## PLANNING TECHNICAL REVIEW COMMITTEE –AGENDA

## PLAN SNAPSHOT REPORT WAIV-2023-0006 FOR CITY OF DOVER, N.H.

**RE: Second Street Courthouse – Site Plan Amendment  
10 Second Street  
Dover Planning File: P21-30**

**TO:** Donna Benton, Planner, City of Dover      **DATE:** 6/8/2023  
**FROM:** Neil J. Rapoza, PE  
CIVIL CONSULTANTS  
**SUBJECT:** Plan Revision Memo  
**PROJECT:** 20-279.00 One First Street, LLC (Dover project #P21-30)

NEIGHBORHOOD  
PLAN AND ABUTTER  
INFORMATION

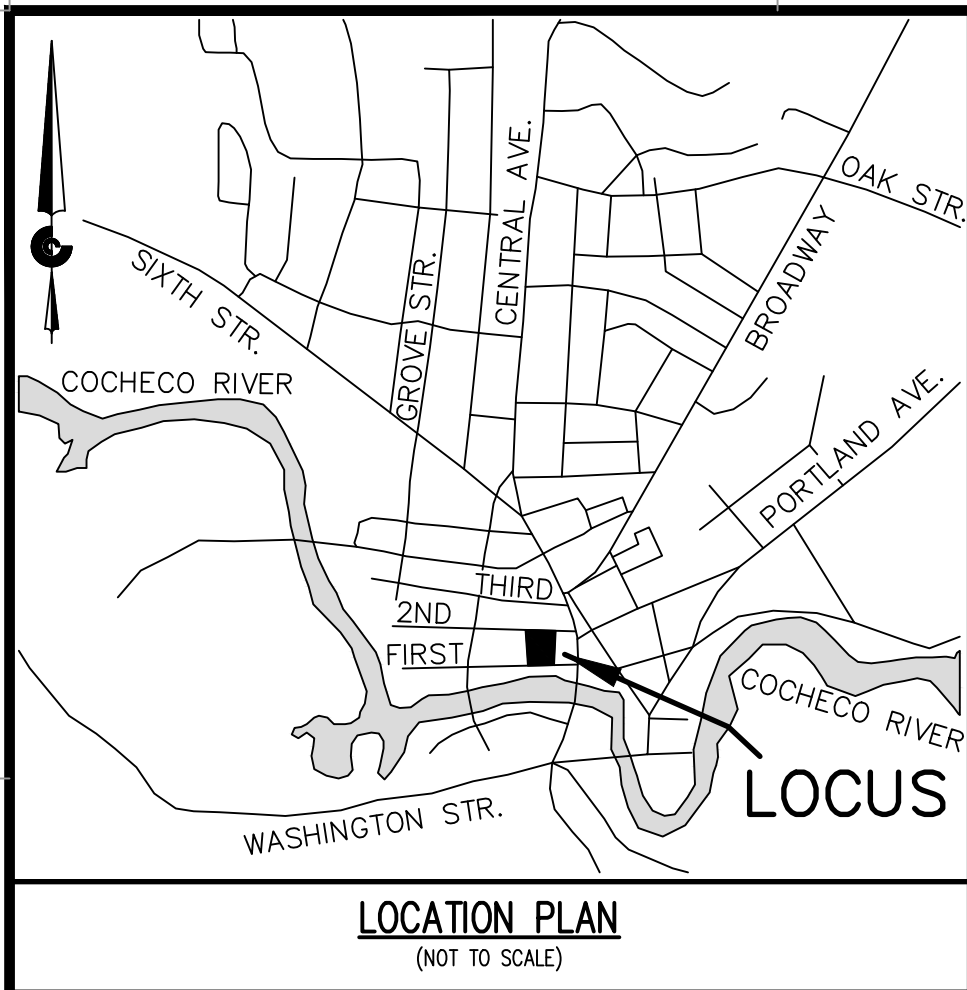
#### Sheet C1

- a. Added sheets LP6 – LP8 to index.
- b. Updated owner information on abutting lots.
- c. Revised site outline to reflect proposed site modifications.

**NEIGHBORHOOD TOPOGRAPHY PLAN**

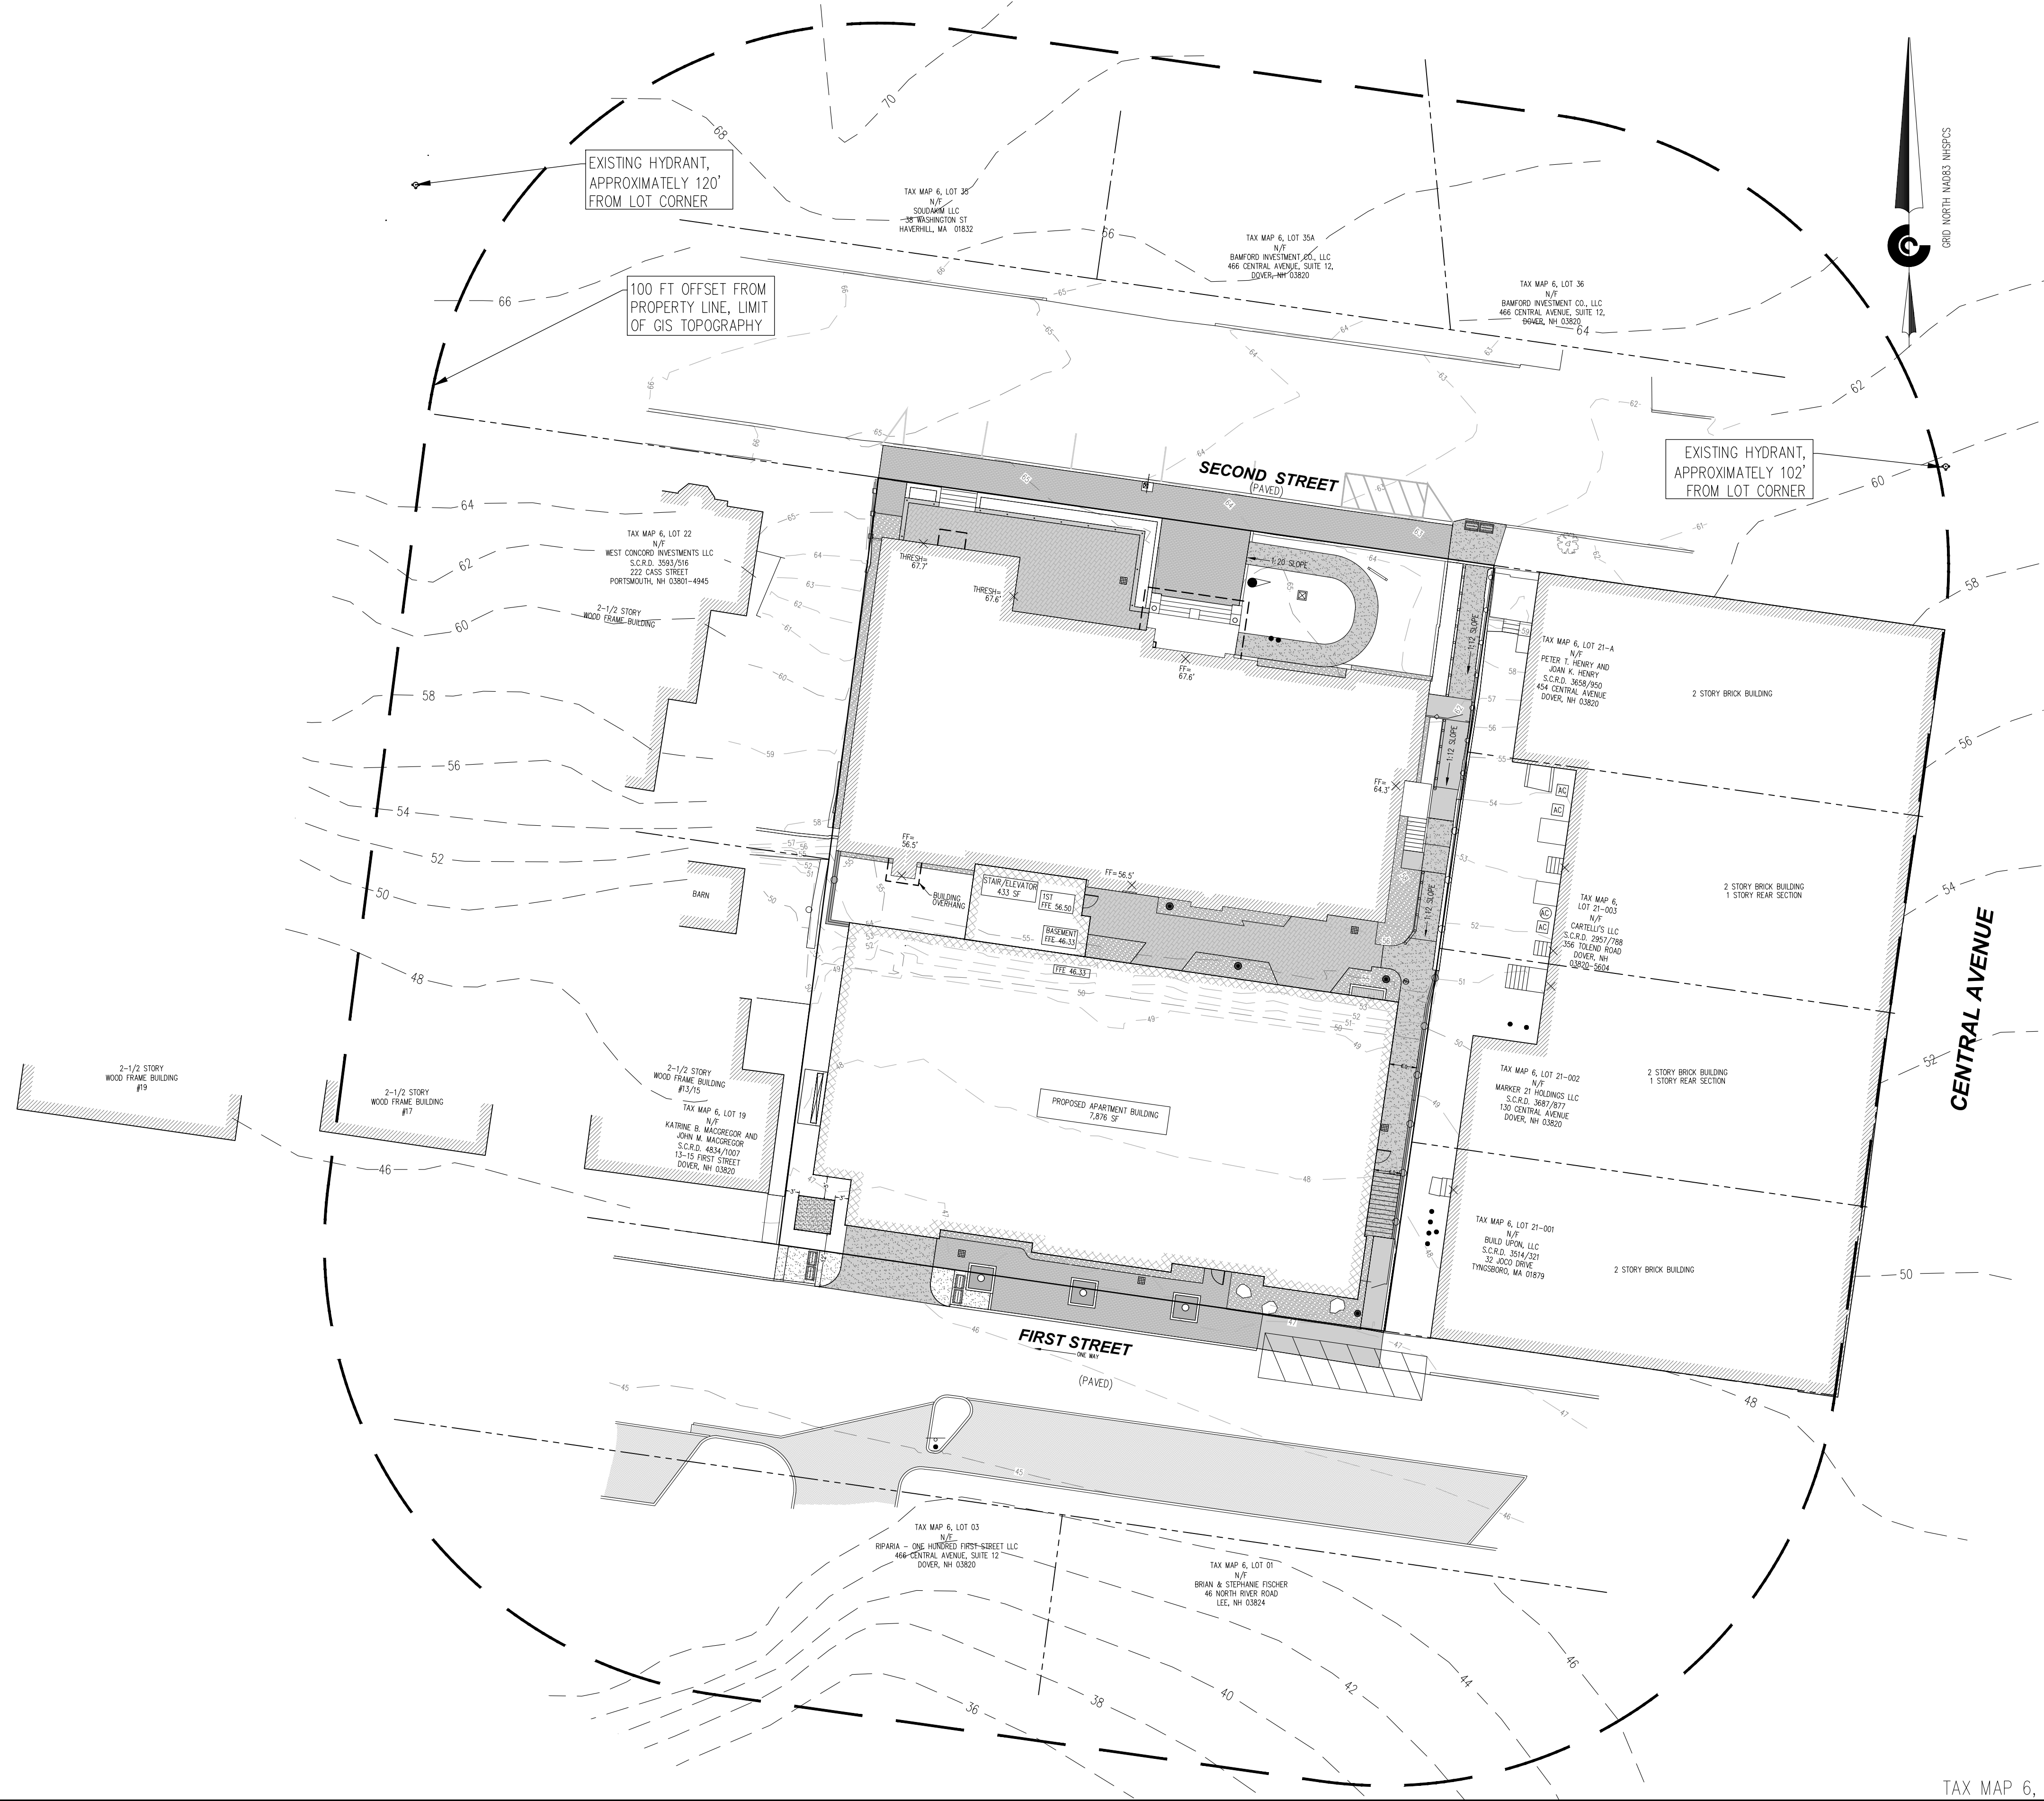
#### Sheet L1

- a. Updated owner information on abutting lots.
- b. Revised First Street site modification to include patio and planter.
- c. Revised stair and planter configuration at east alley to accommodate existing utilities encroaching on subject lot.
- d. Revised transformer pad per Eversource request.
- e. Added fire hydrant information inadvertently left off the approved plan.
- f. Added topography inadvertently left off the approved plan.

**PROPOSED SECOND STREET UTILITY PLAN**

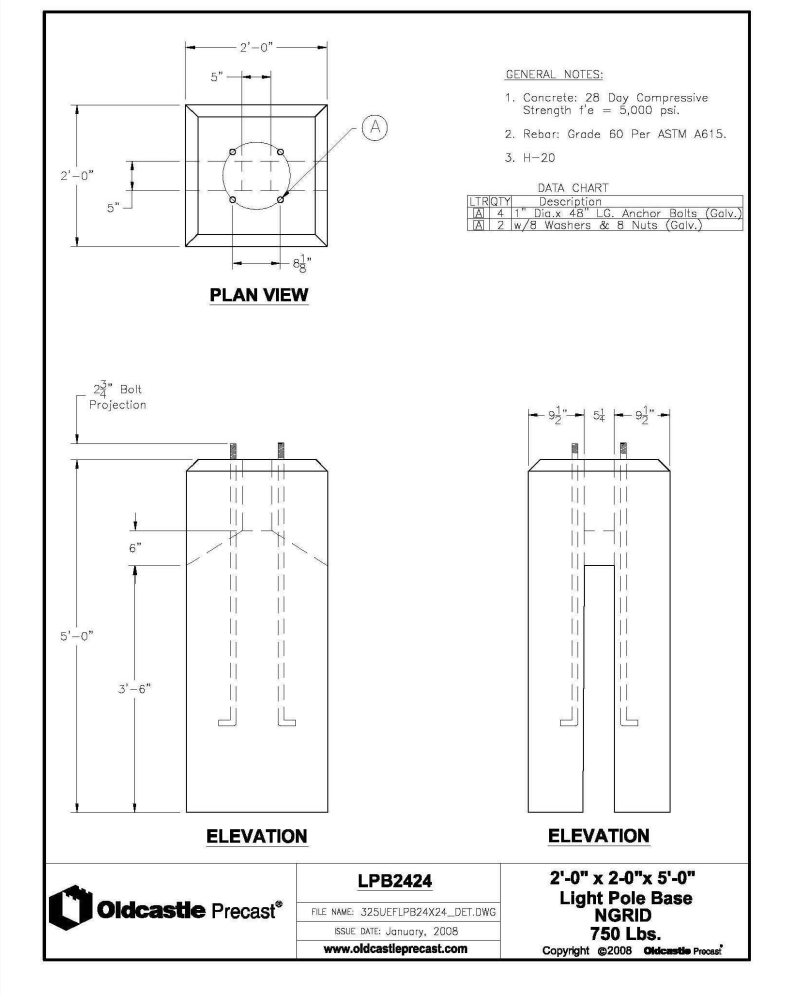
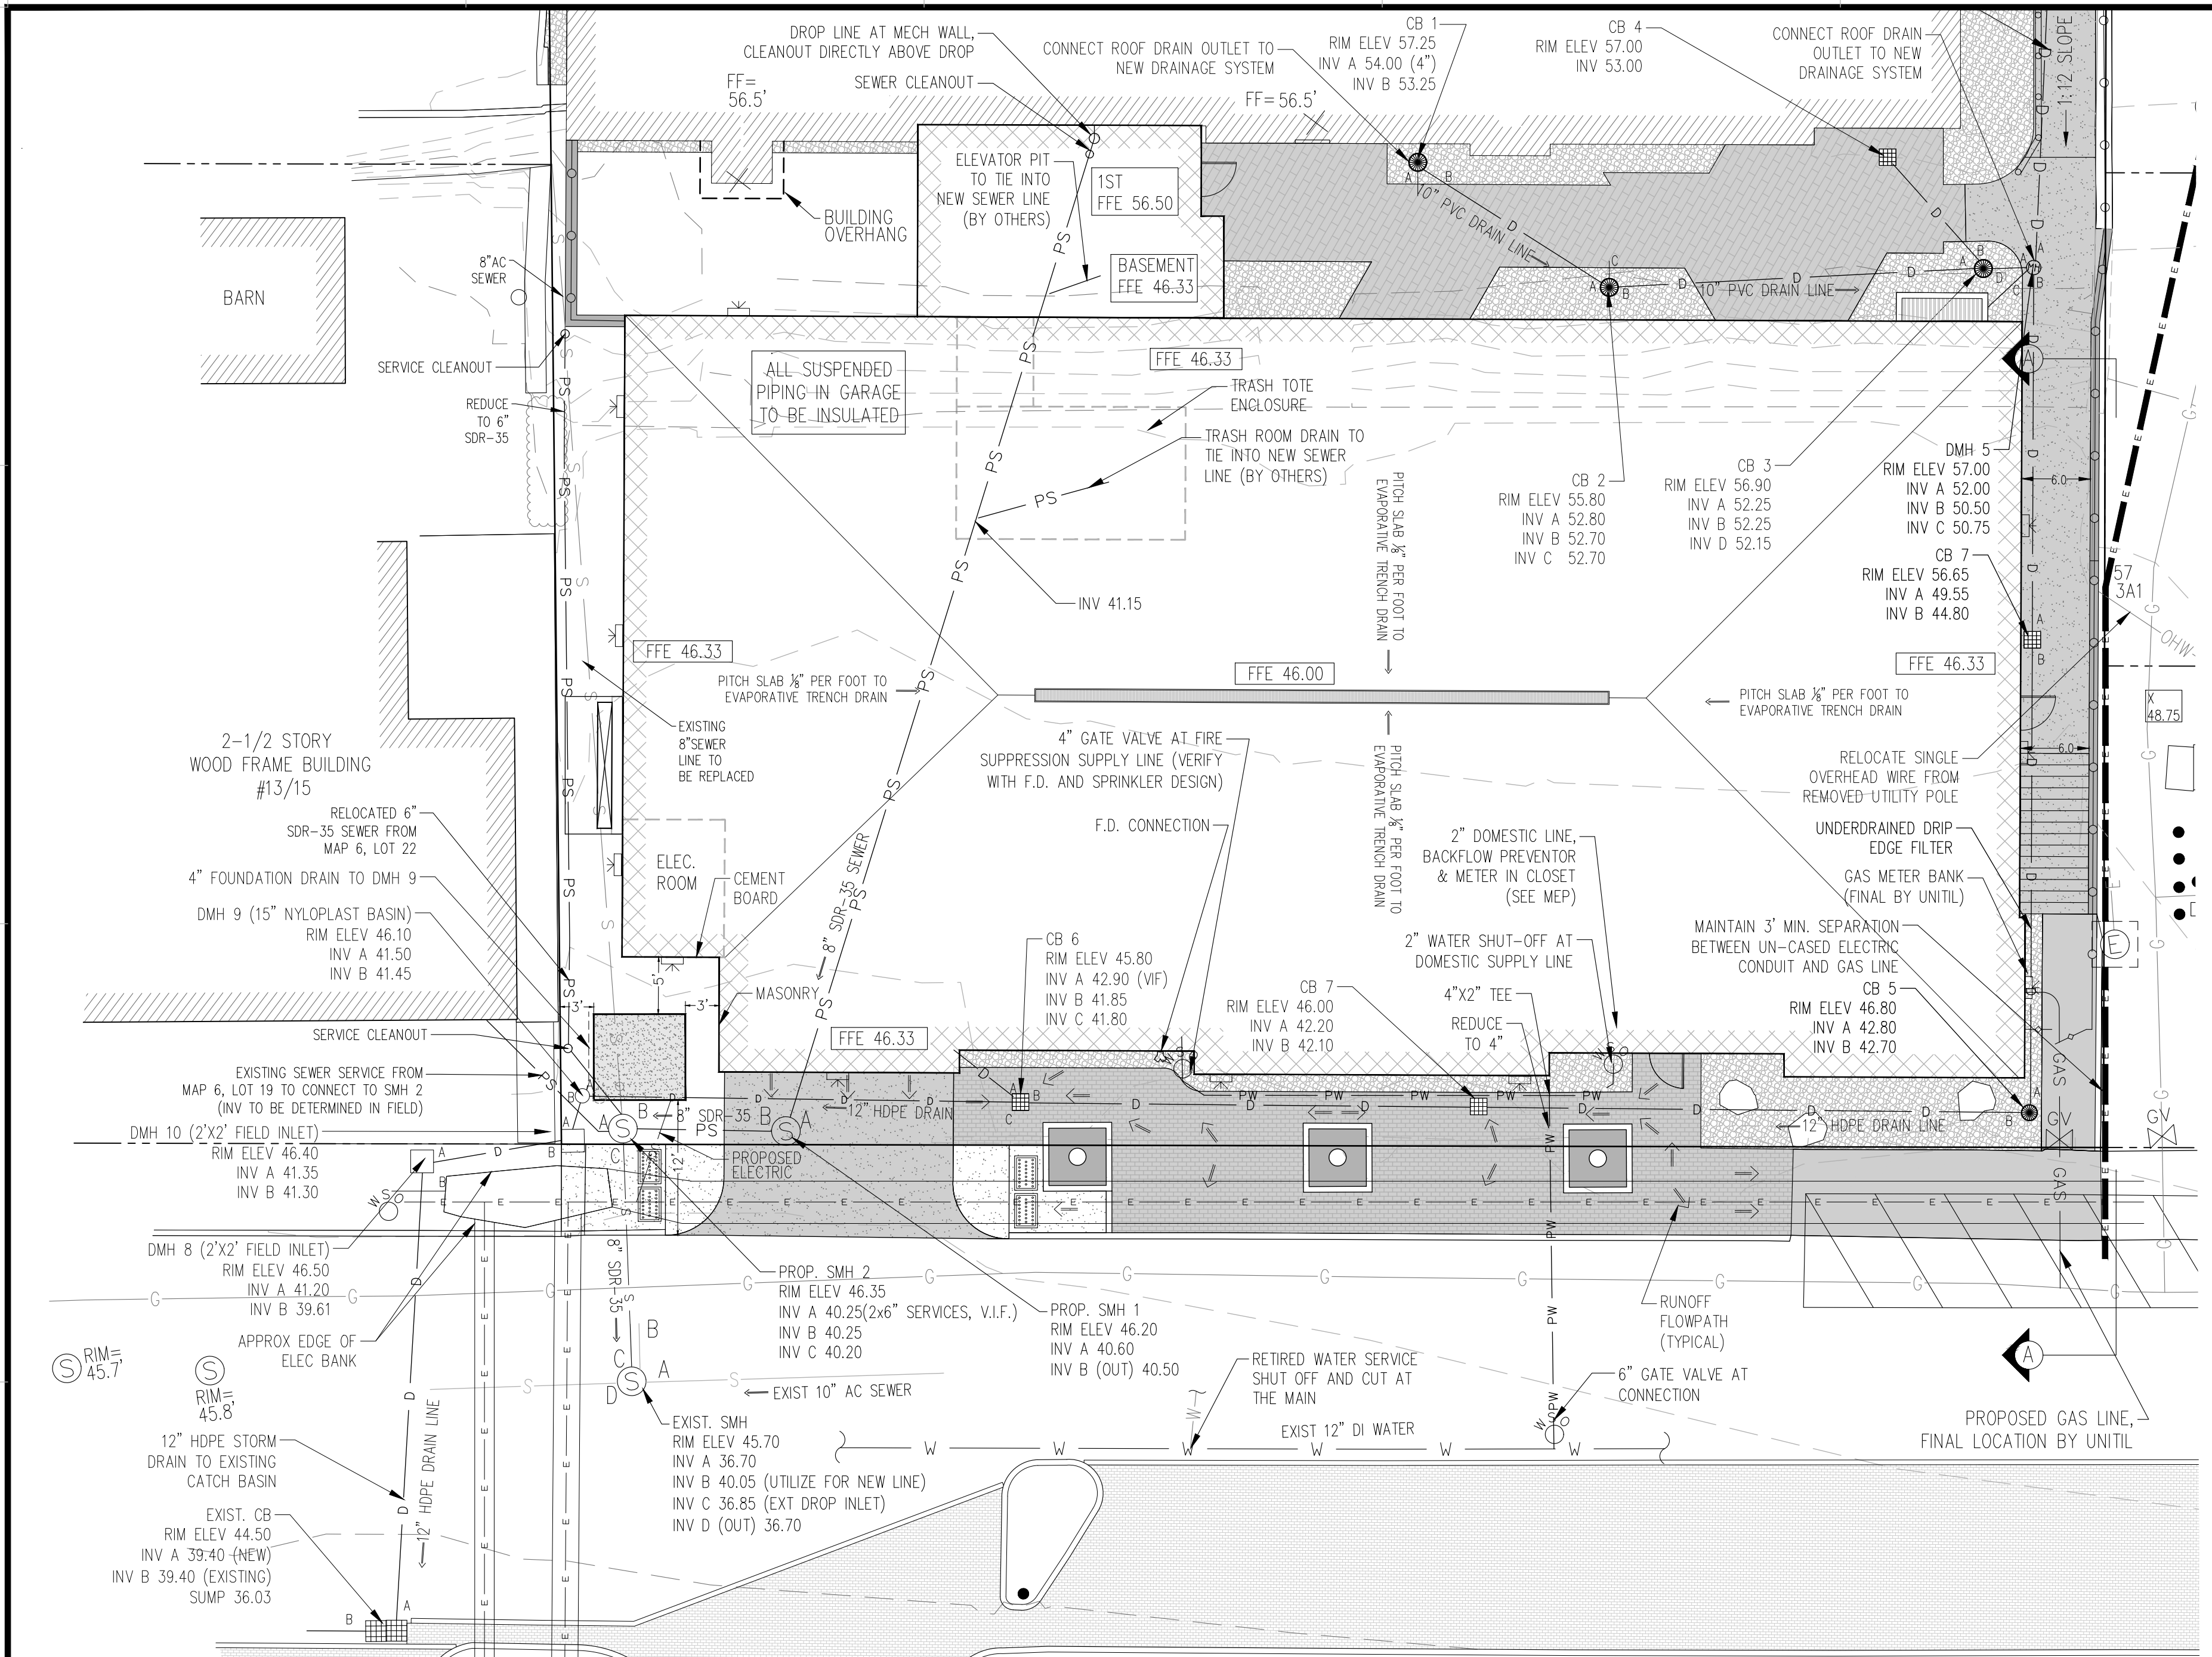
#### Sheet L4

- a. Revised First Street site modification to include patio and planter.
- b. Added underdrained paver patio layout and associated drainage structures.
- c. Added spot grades and notes relevant to proposed Second Street patio.
- d. Added detail for tiered block planter system at proposed patio.
- e. Indicate partial proposed lighting (refer to landscaping plans for final lighting).
- f. Added reinforced concrete notes applicable to exterior stairs and slabs.
